553 WEST 7TH AVENUE (COMPLETE APPLICATION)
DE414251 - ZONE C-3A

DEVELOPMENT PERMIT STAFF COMMITTEE MEMBERS

DEVELOPMENT PERMIT STAFF COMMITTEE RECOMMENDATION: APPROVE

PROPOSED BUILDING MASSING
 SOUTH ELEVATION

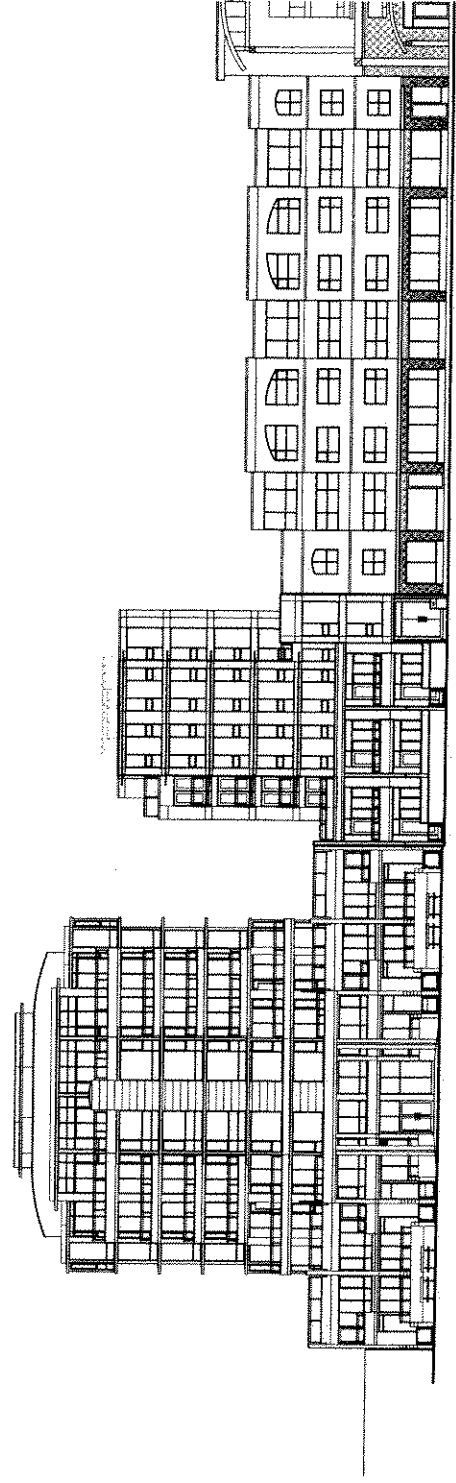
1.2 design development to the expression of the lower two floors of the south (West 7th Avenue) elevation, to improve their relationship to the upper floor massing, and to the street;

Note to applicant: Strengthening the proposed podium expression of the lower floors may be one option. Integrating the lower floors into the tower form by using a common structural grid could also be explored. Increasing light penetration to the interior spaces at both levels is encouraged.

ii) the proposed glass sunshades on the south (West 7th Avenue) elevation;

Note to applicant: A metal louvre system should be considered. Other options may be possible.

SHEET TITLE
 BASEMENT PLANS

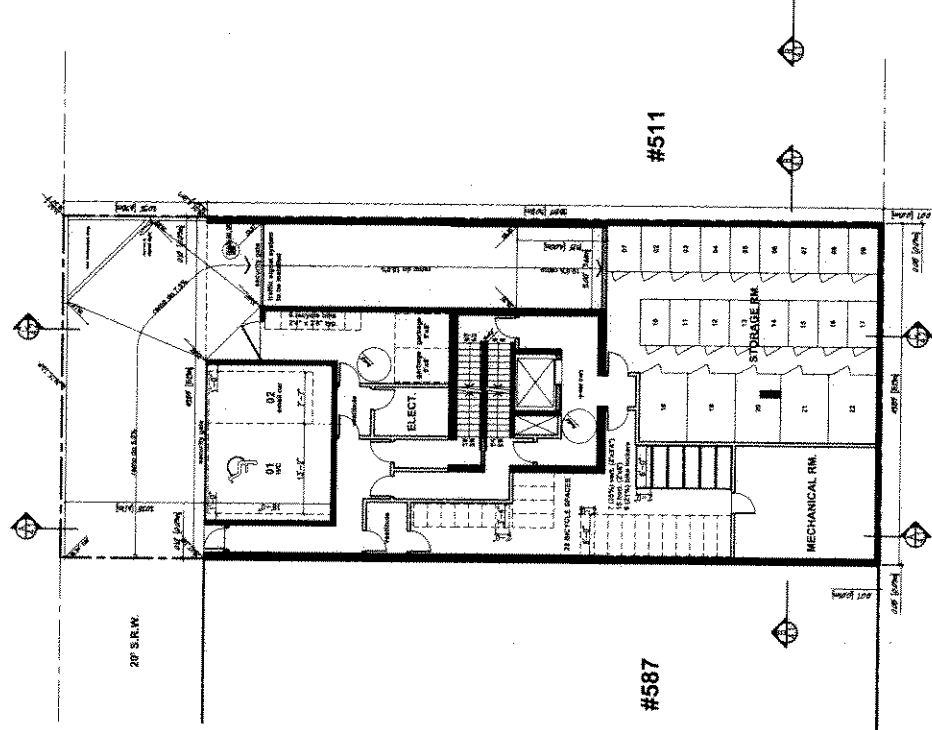
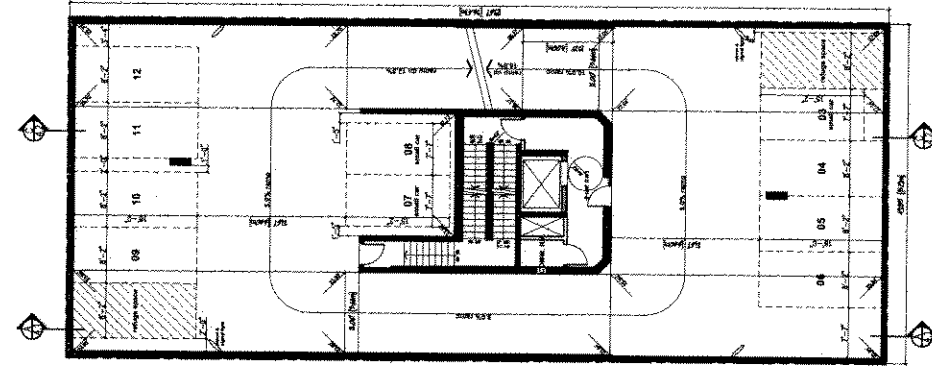
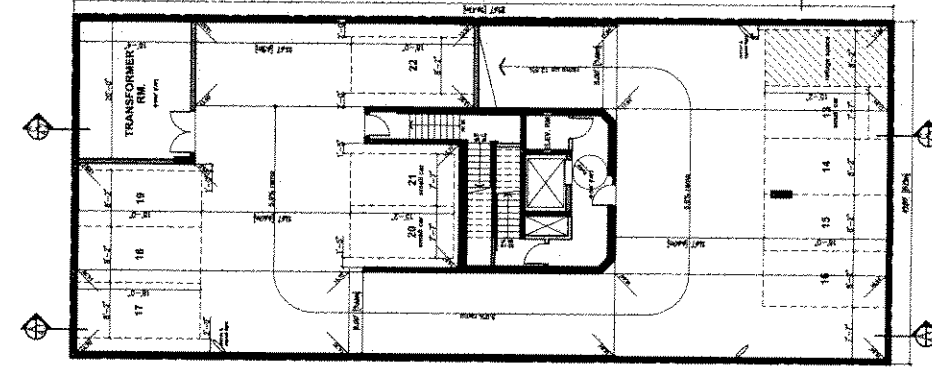
Note to Applicant: A note can be added to Parking Level 1 plan to satisfy this requirement.

3RD FLOOR PLAN

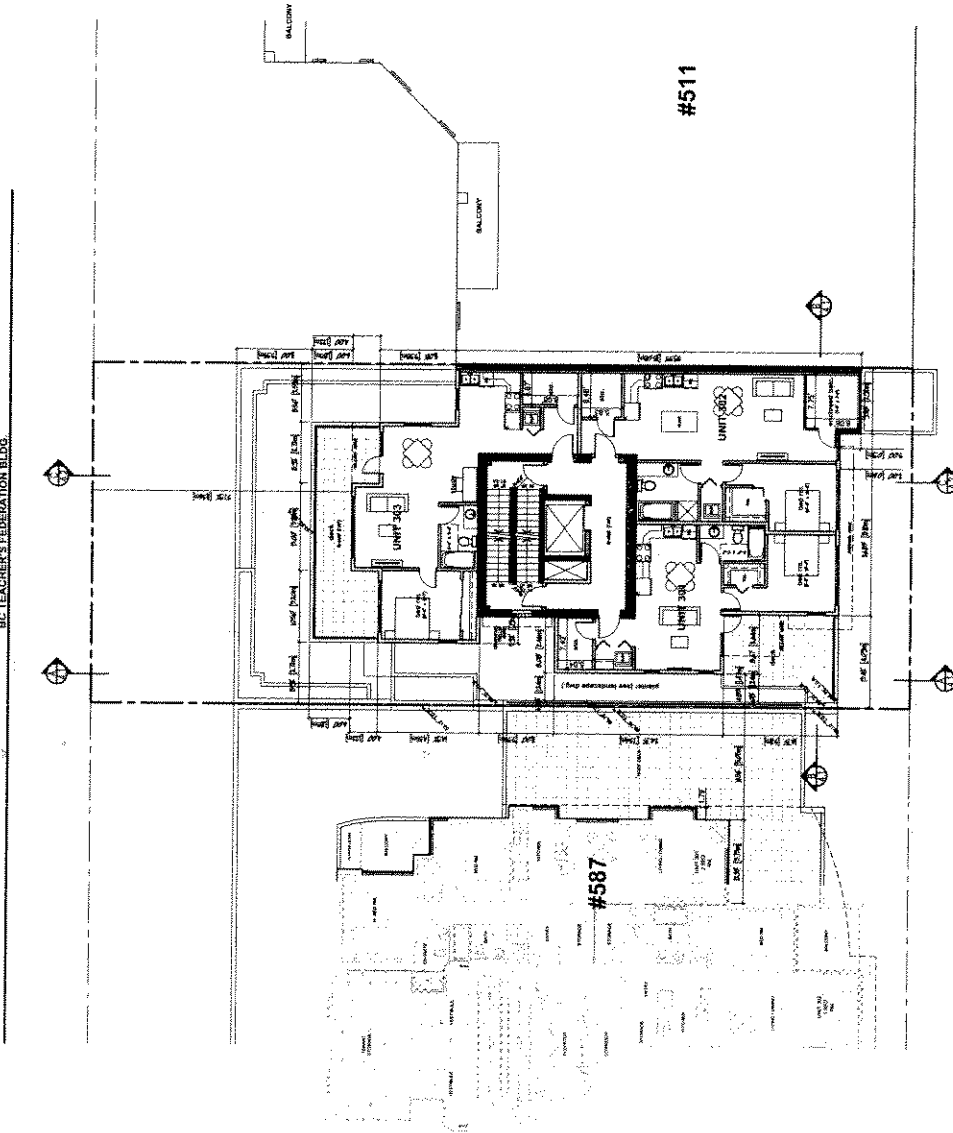
i) providing a minimum 5 foot high privacy screen along the west property line at the third floor level;

Note to applicant: This is in addition to the landscape screen provided. A high quality material, such as obscure glazing, is encouraged.

Sheet Title
ROOF PLAN

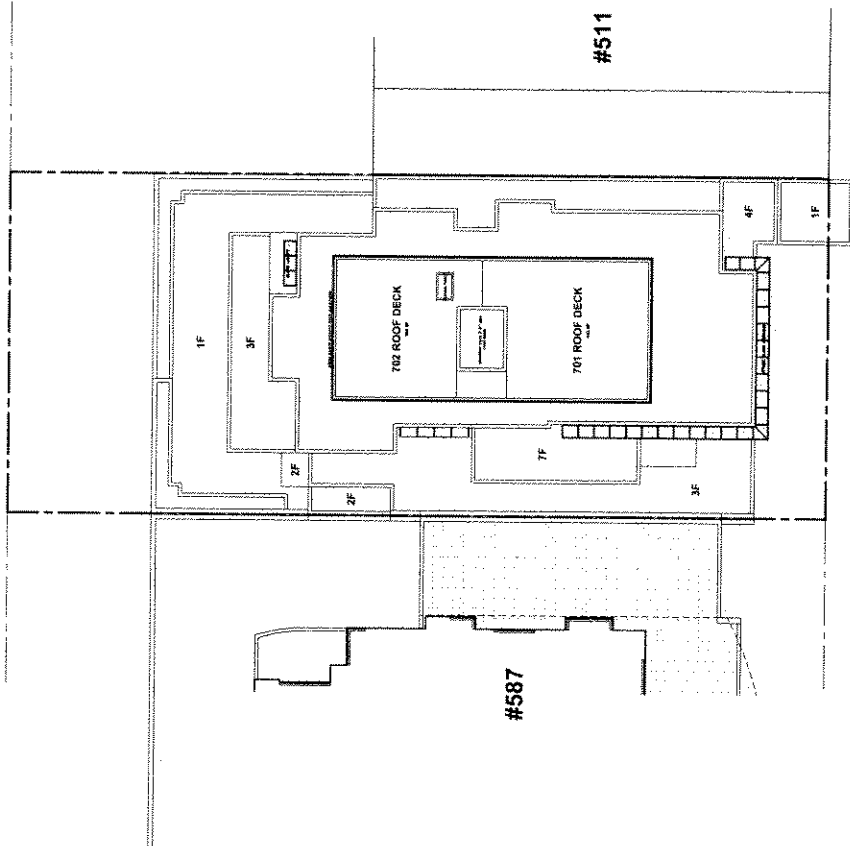
v) deletion of proposed private roof decks at the uppermost roof level;

Note to applicant: A smaller, common roof deck may be considered provided that the height of any access and privacy screening is minimized, and the deck is located so as not to negatively impact privacy of adjacent buildings.
